147 Major St — HVAC clash mark-up

HVAC Designs LO# 113963 (HVA 26 167838) vs permit 26 167838 BLD 00 · PalmView BIM review · Oct 22, 2026

Two systems: F-1 basement (basement + main floor from below) · F-2 2nd-floor mech room (2nd + 3rd floors from the 3rd-floor joist space).

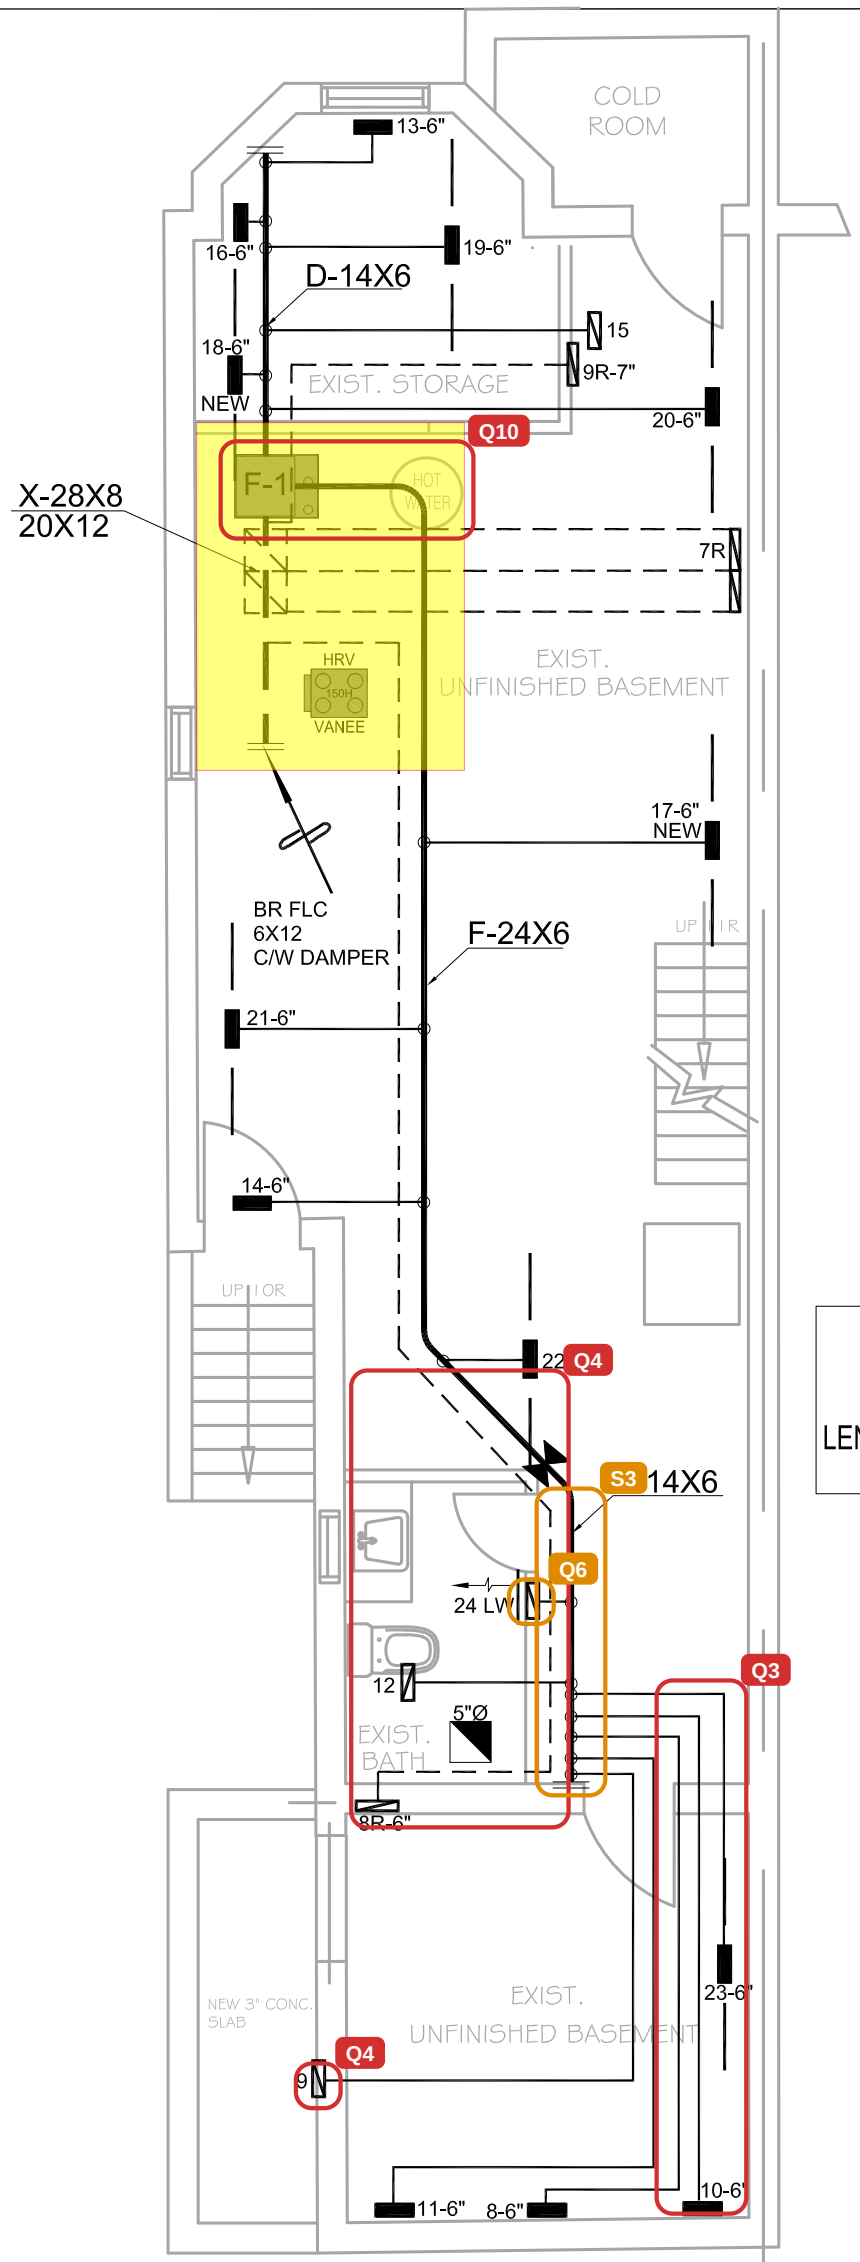
High-wall grille + 7" stack behind the 72" vanity, mirrors, sconces and feature tile. Owner: HVAC Designs / designer. Status: OPEN.

Q2 Bedroom 2 ceiling: joist direction and trunk B on LVL1

Q5 Return 3R on the ensuite vanity / mirror wall

Q6 7" return stacks in 2x4 walls (1R–6R, 9R) and 6" supply stacks

Q11 Stair direction 2nd → 3rd

Sheet Title
BASEMENT HEATING LAYOUT

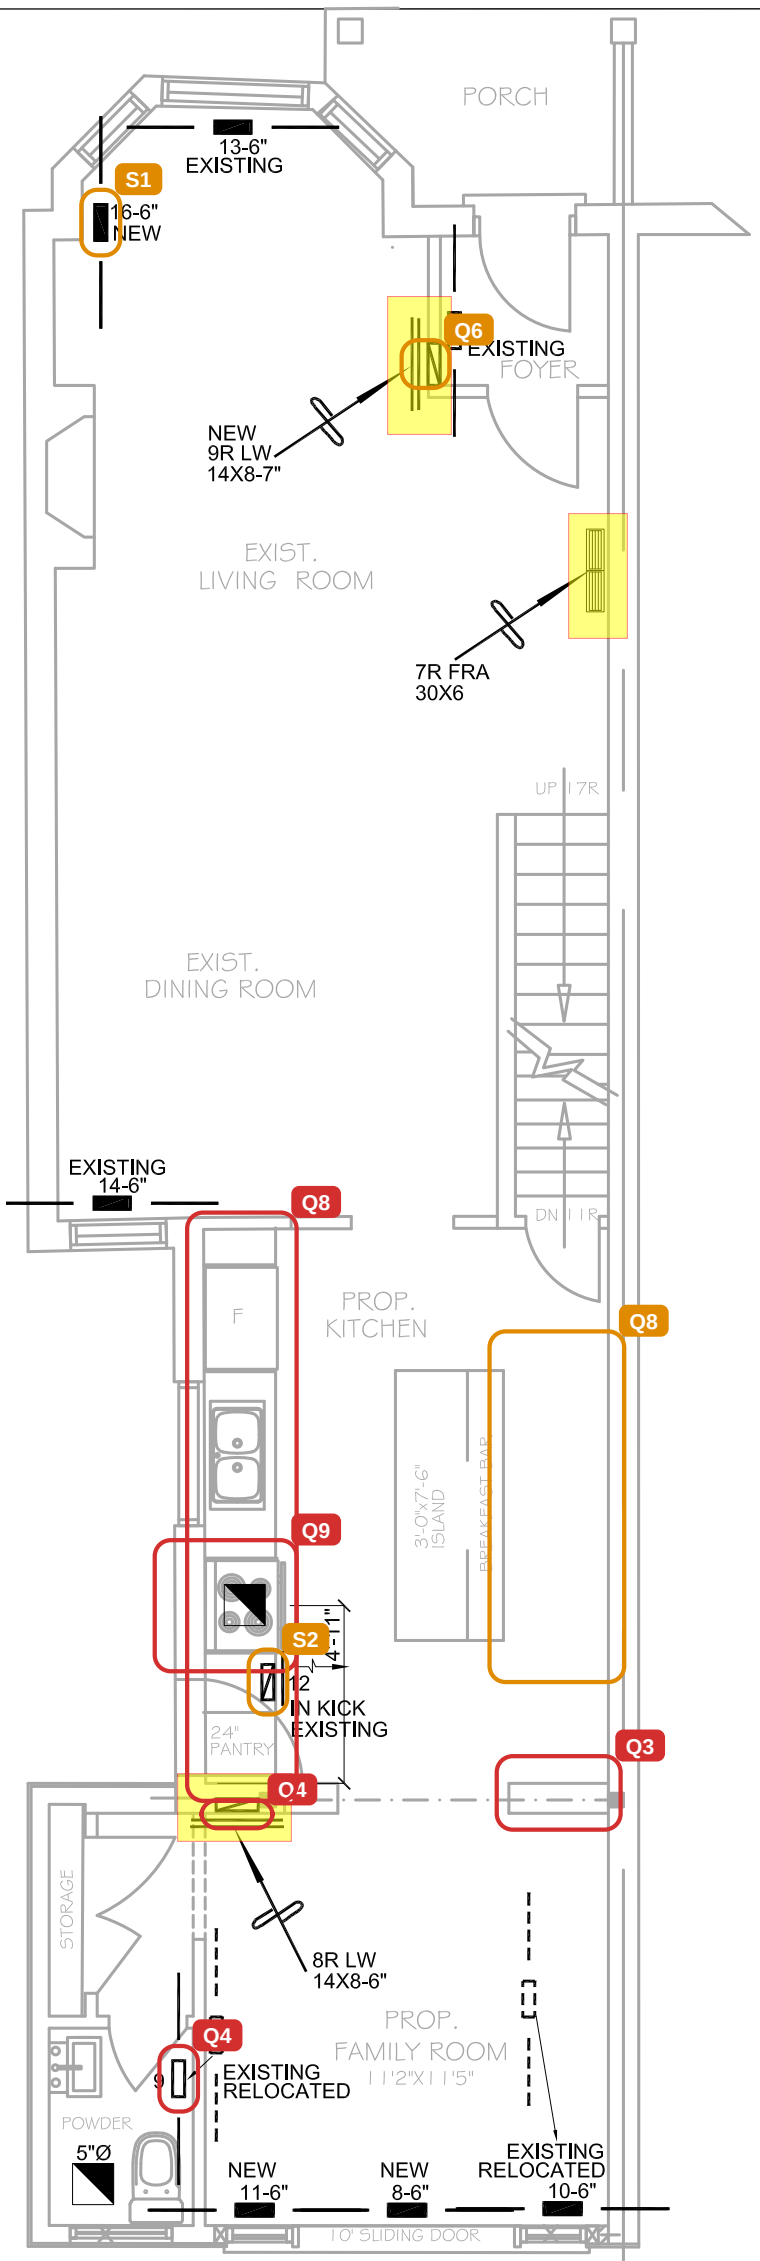
Core three holes in the brick, or route all rear branches through the existing 30" opening. Owner: HVAC sub. Status: OPEN.

Both stacks land on top of existing masonry (powder E wall, pantry/storage double wall). Relocate. Owner: HVAC Designs. Status: OPEN.

F-1 not tagged existing and sits where the permit shows the existing H.E. furnace. Takeoff runs over the tank vent. Owner: PalmView. Status: OPEN.

Q3 Rear branches 8, 10, 23 through the old rear foundation

Q4 Supply 9 and return 8R sit on old foundation walls

Q6 7" return stacks in 2x4 walls (1R–6R, 9R) and 6" supply stacks

Q10 F-1 new or existing; hot water tank vs plenum

S3 Trunk E ends ½" off the old rear wall

Sheet Title
FIRST FLOOR HEATING LAYOUT

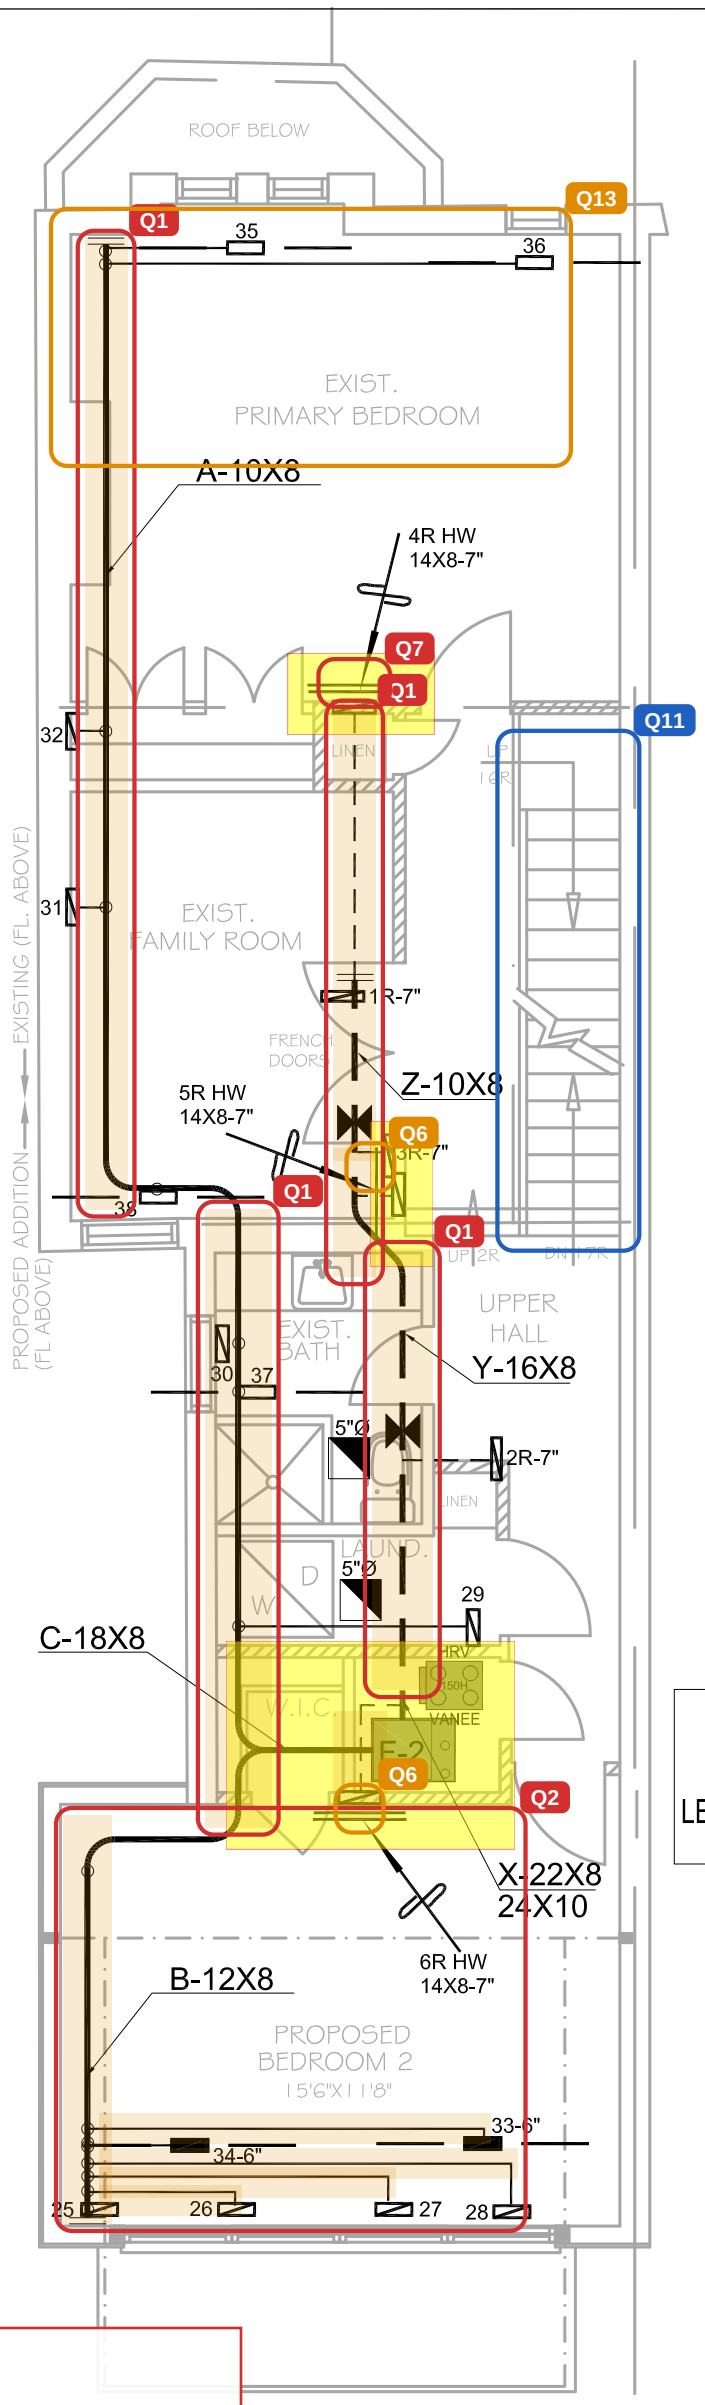
Permit shows a 30" range and 34" fridge; Miele range and fridge are 36". Cabinet set 186.5" vs 184.6" wall. Aisle to the stair is 34.9". Owner: Cabinet shop / PalmView. Status: OPEN.

Elica Trento insert on the south wing wall under the 2nd-floor overhang. No duct or termination drawn. Owner: HVAC Designs. Status: OPEN.

- Q3 Rear branches 8, 10, 23 through the old rear foundation
- Q4 Supply 9 and return 8R sit on old foundation walls
- Q6 7" return stacks in 2x4 walls (1R–6R, 9R) and 6" supply stacks
- Q8 Kitchen sizes: range, fridge, run length and aisle
- Q9 Kitchen hood exhaust not designed
- S1 Supply 16 boot tight to the bay corner
- S2 Supply 12 kick register under the pantry

Sheet Title
SECOND FLOOR HEATING LAYOUT

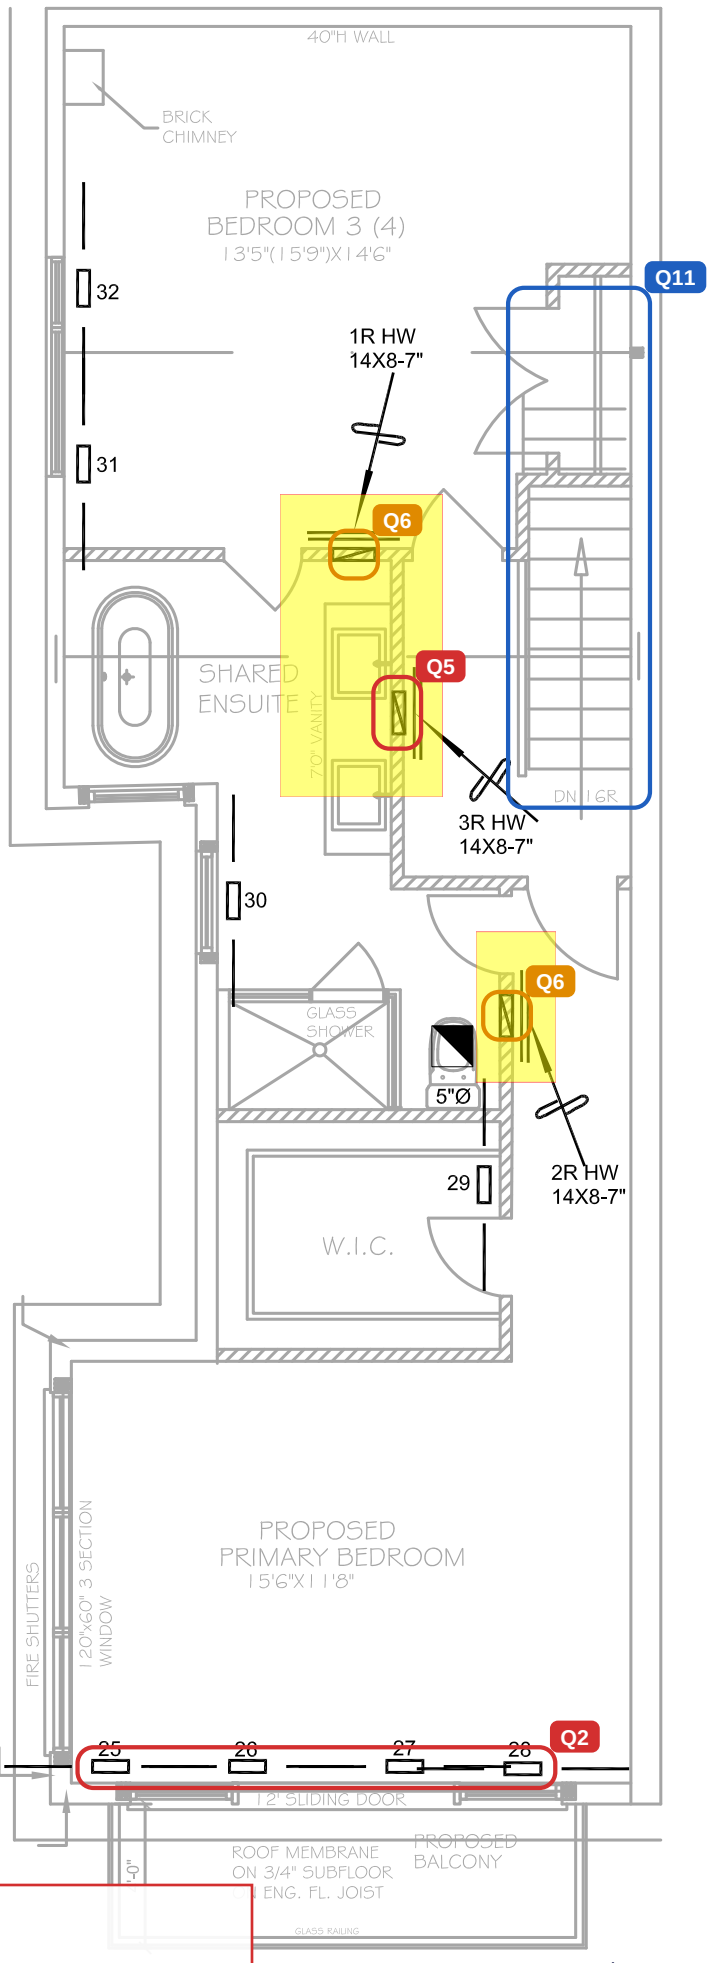
As drawn, the F-2 trunks run front-to-back across side-to-side 3rd-floor joists. Accept bulkheads (~8'-2" clear under 9'-0") or have HVAC Designs reroute. Owner: PalmView / client. Status: OPEN.

Grille is on the closet wall right under LVL5; the stack cannot pass the beam. Owner: HVAC Designs / engineer. Status: OPEN.

Plans A8/A9: new stair stacked over the existing one, rising front-to-rear. Section A-A draws it rising rear-to-front. Owner: PalmView / designer. Status: OPEN.

Trunk A (first 6.7 ft) and branches 35/36 are under the existing front roof. If that space is outside the insulation, ducts need R-12 + Class A sealing (permit note). Owner: PalmView. Status: OPEN.

Q1 2nd-floor ceiling bulkheads (F-2 trunks A, C, Y, Z)

Q2 Bedroom 2 ceiling: joist direction and trunk B on LVL1

Q6 7" return stacks in 2x4 walls (1R–6R, 9R) and 6" supply stacks

Q7 Return 4R stack vs the LVL5 flush beam

Q11 Stair direction 2nd → 3rd

Q13 Front roof space over the primary bedroom
